November 14, 1996
JPN-96-043

SUBJECT: James A. FitzPatrick Nuclear Power Plant
Docket No. 50-333
**Response to Request for Additional Information
Regarding Power Uprate**

REQUEST FOR ADDITIONAL INFORMATION REGARDING POWER UPRATE

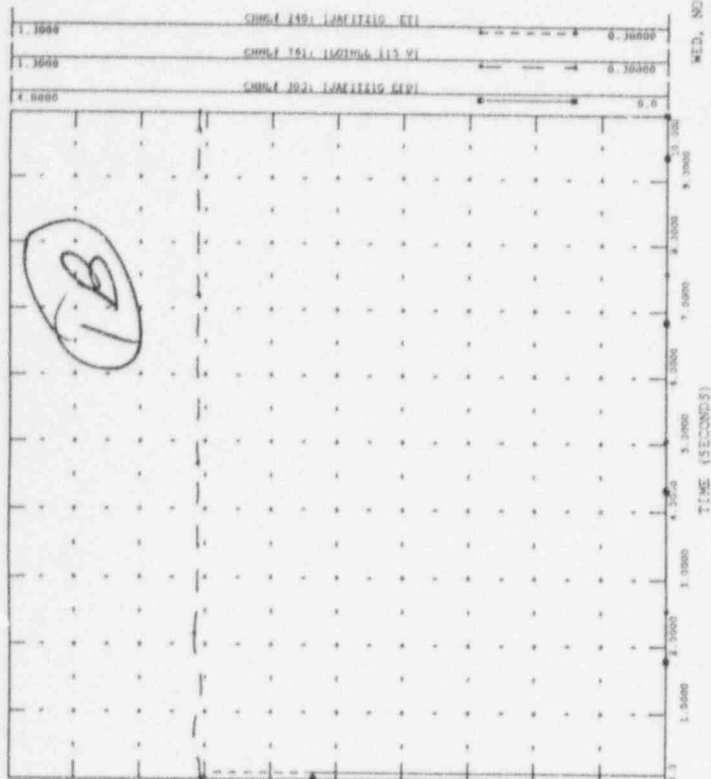
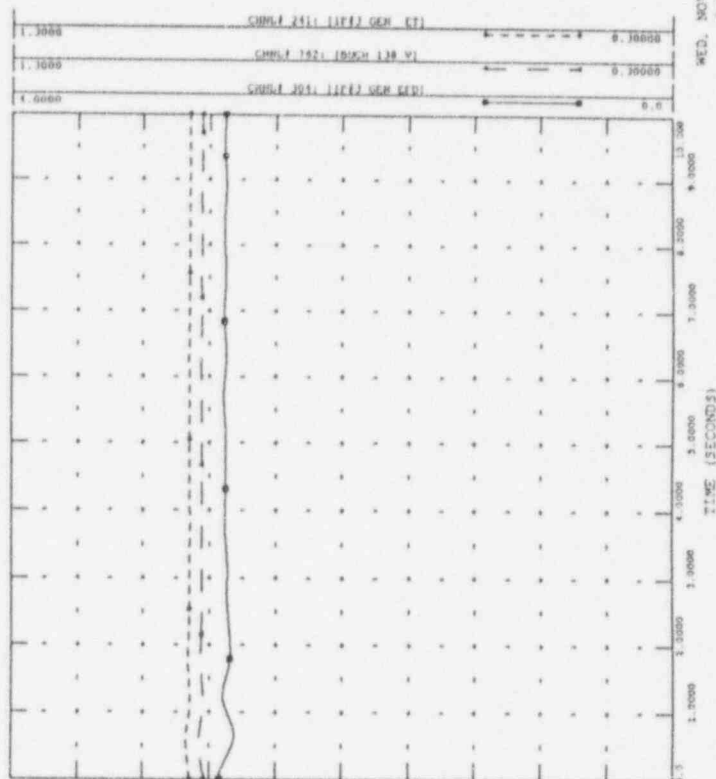
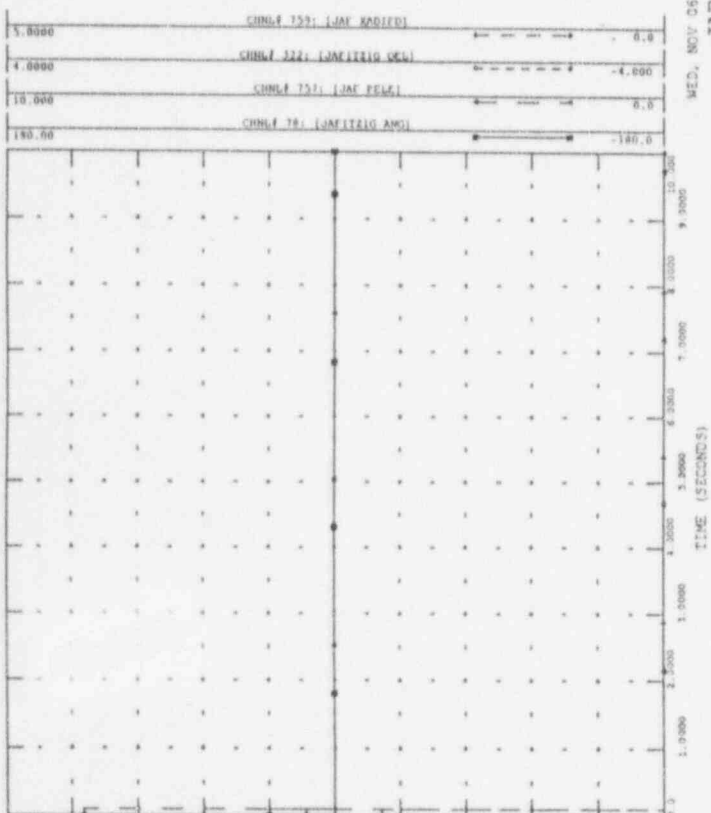
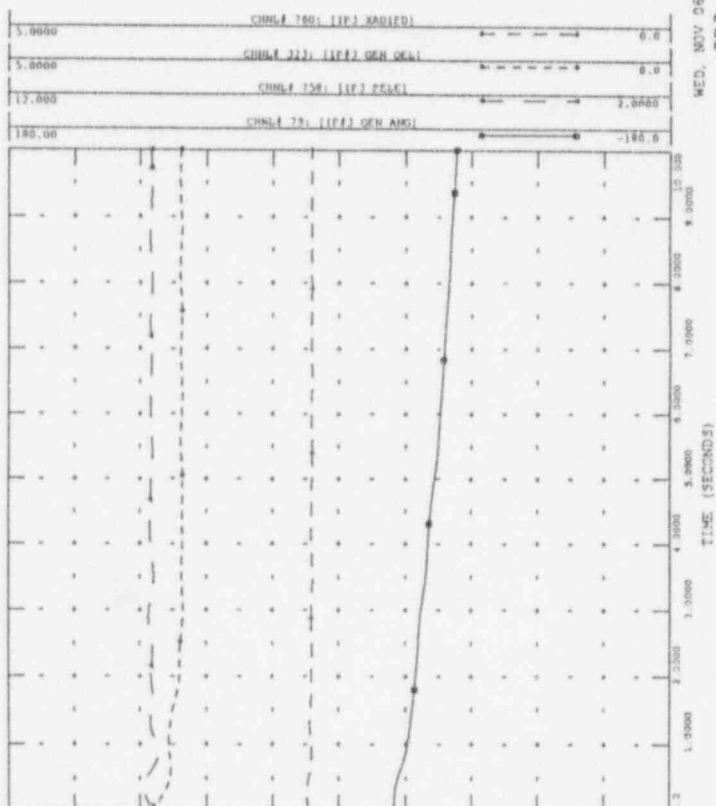
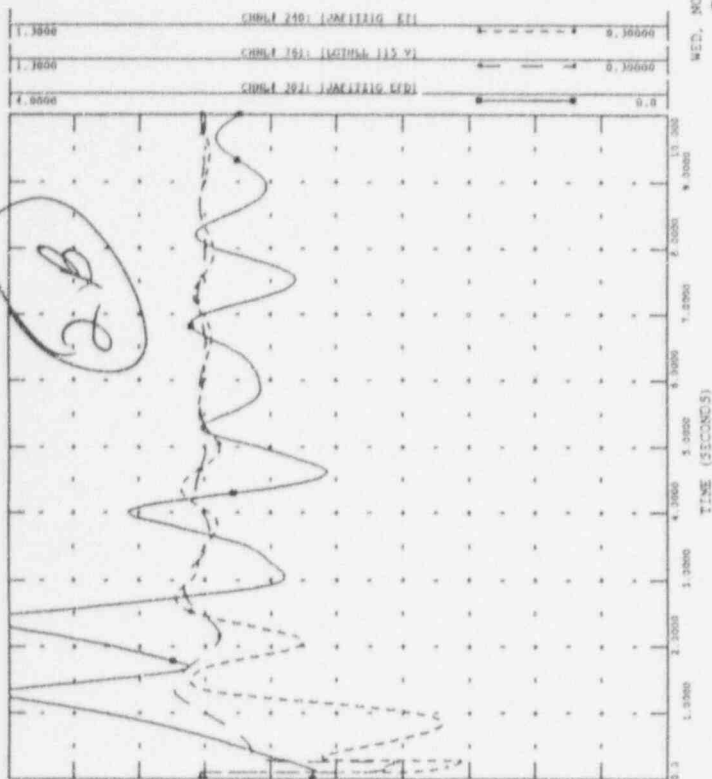
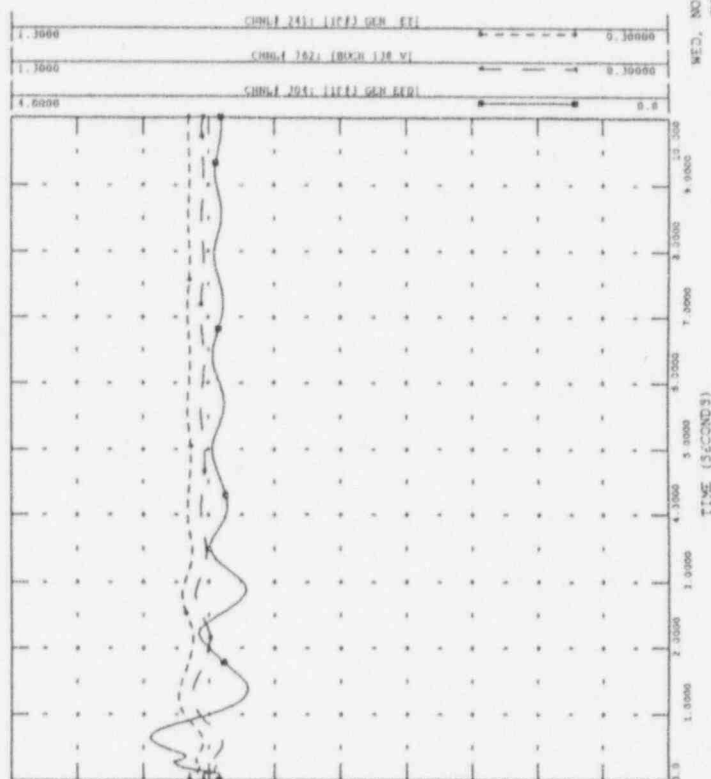
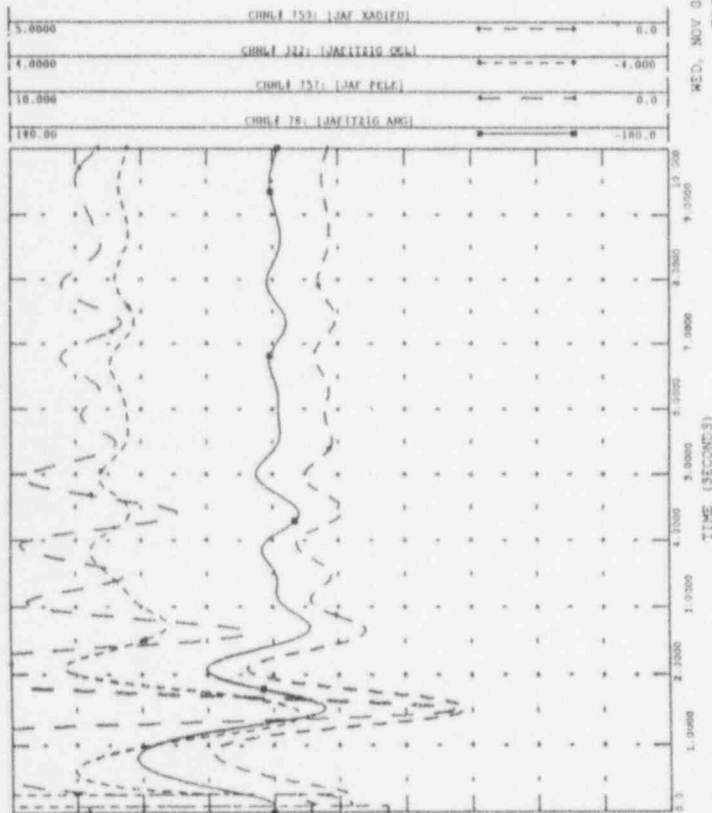
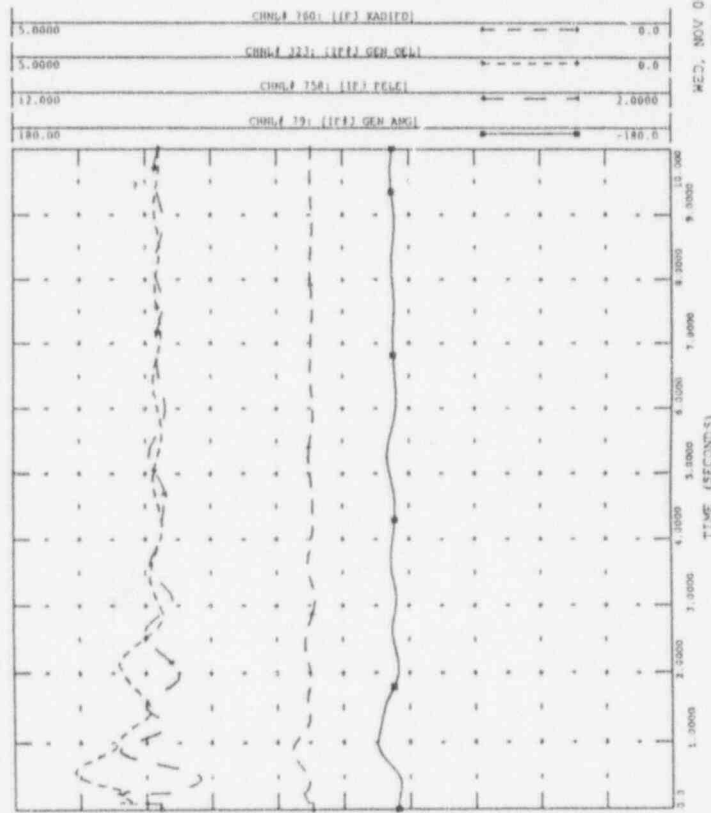
Does the offsite and the onsite power distribution systems/grid stability conform with GDC17, Appendix A to 10 CFR Part 50?

Stability simulations were conducted with the FitzPatrick unit loaded to 883 MW gross electrical output. Stability swing curves (Curves 1A and 1B attached) show well damped and stable results for a loss of FitzPatrick generation. Stability swing curves (Curves 2A and 2B attached) show well damped and stable results for the most severe normal criteria contingency (i.e., stuck R935 breaker at Scriba).

Based on the revised operating guidelines that will be in place, the FitzPatrick unit will remain stable under power uprate conditions.
